TO: The US Department of Energy

FROM: The Colorado Department of Health

SUBJECT: Review and Comment, IM/IRA for Surface Water in OU 2,
903 Pad, Mound, and East Trenches

FIGURE 2-7
POTENTIOMETRIC SURFACE OF THE
UNCONFINED GROUND-WATER
FLOW SYSTEM

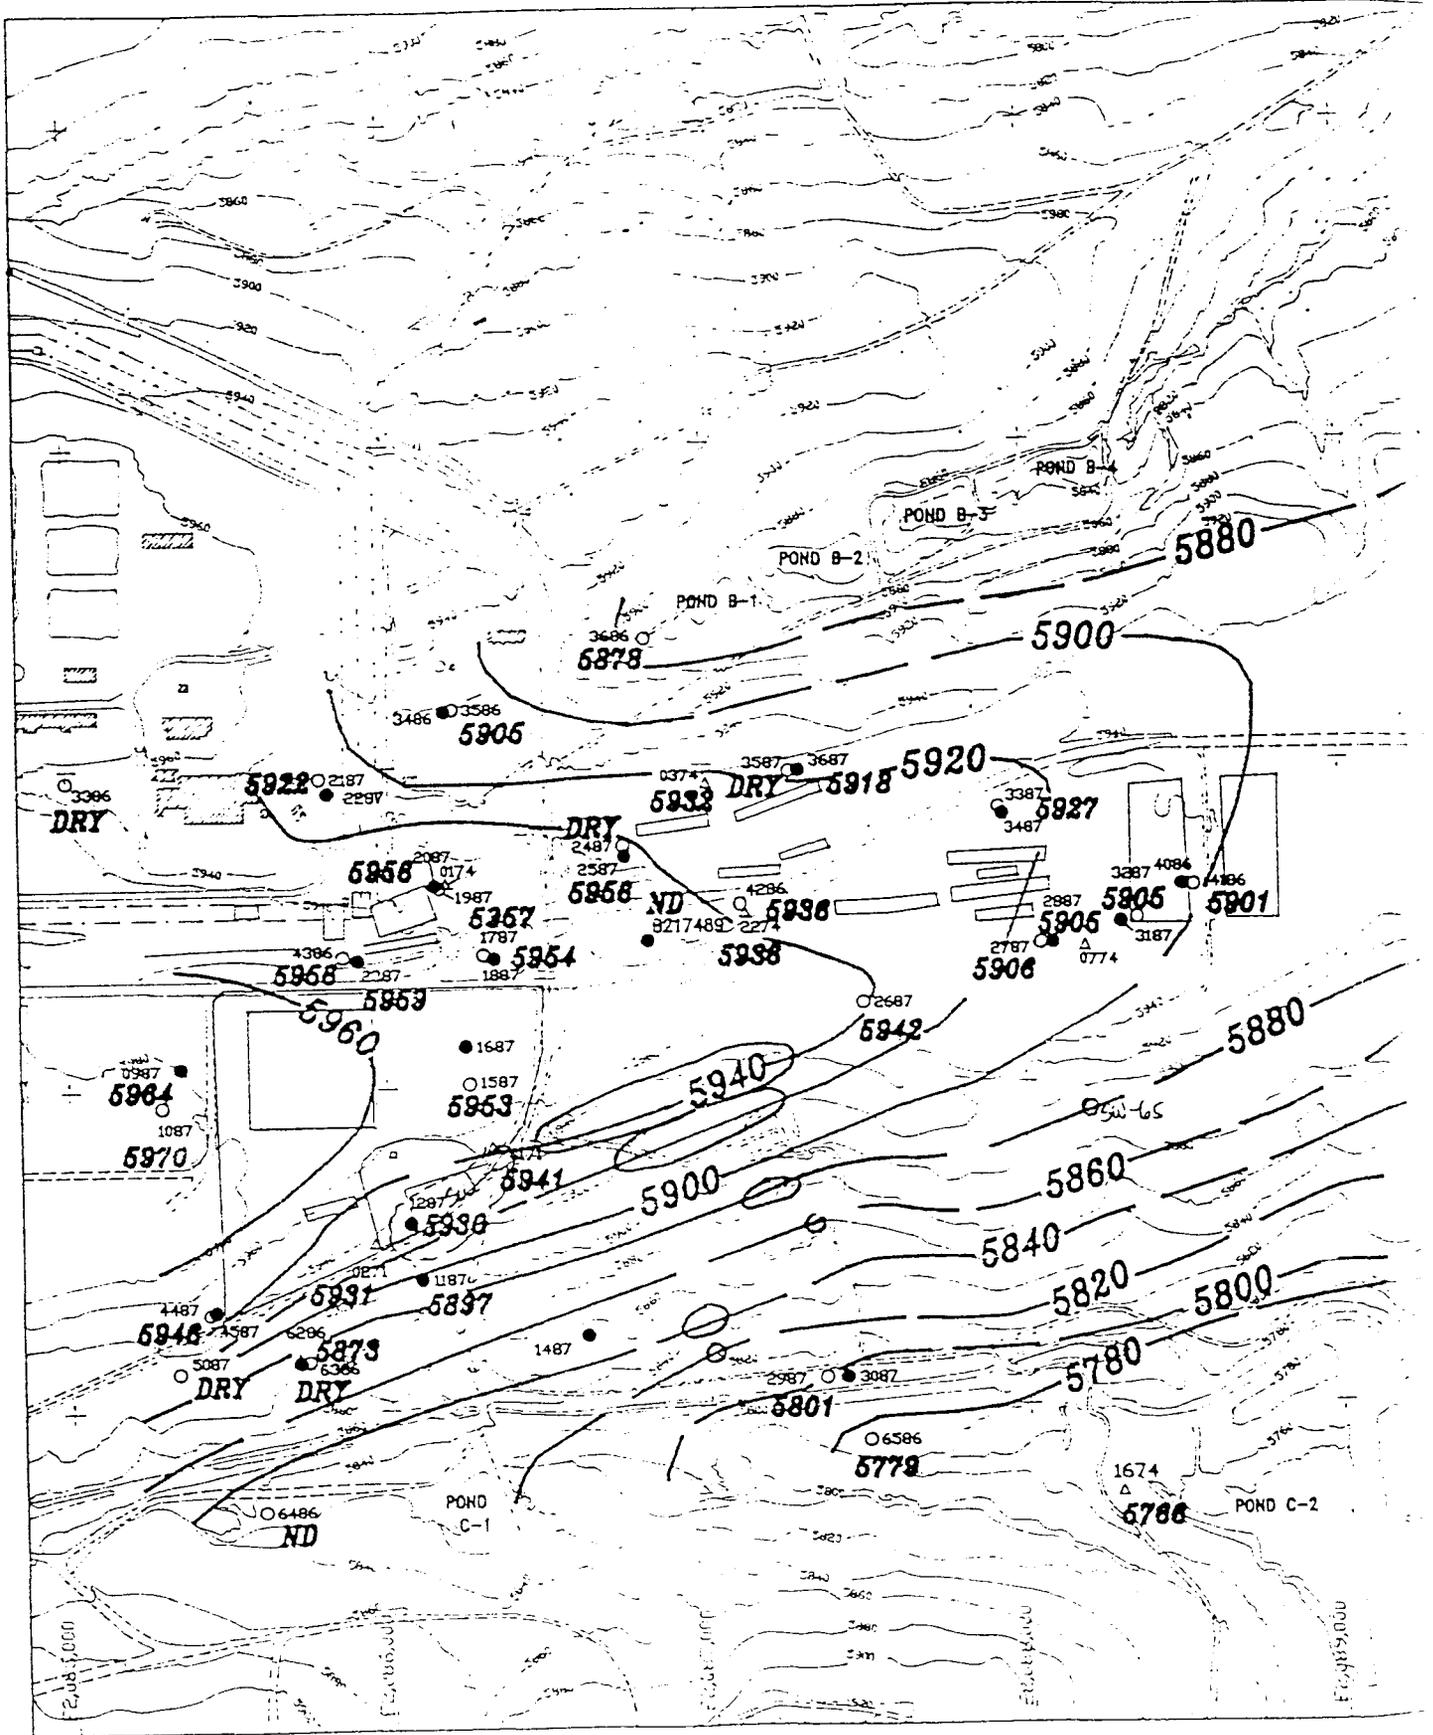
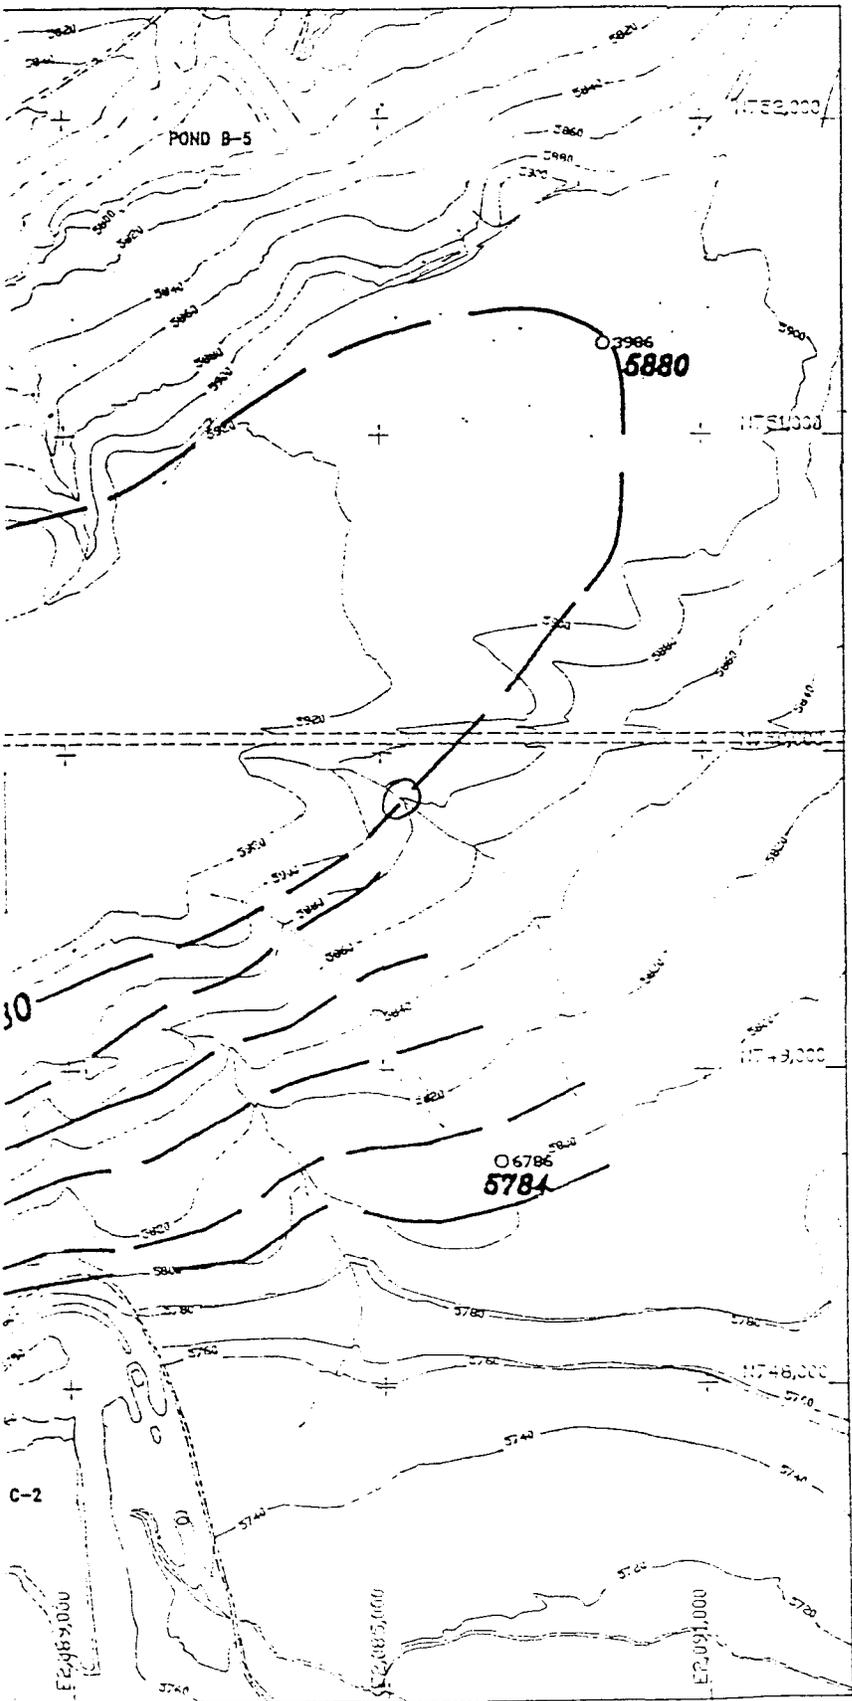
Comment 2: Section 2.2.3.2 Figure 2-7

As this map is contoured, there are several places where the potentiometric surface is above the topographic surface. Some of these places are on or near known surface seeps and it is reasonable to expect that the potentiometric surface would be equivalent to, but not higher than (as shown currently on the map), the ground surface at these locations. There are also several other places on the map where a similar phenomenon is indicated where seeps have not been found. The reverse is also true. Several of the known surface seeps are shown with the potentiometric surface well below their topographic elevation. Please review this figure and correct the contours accordingly (see attached copy of Figure 2-7 for examples of the above).
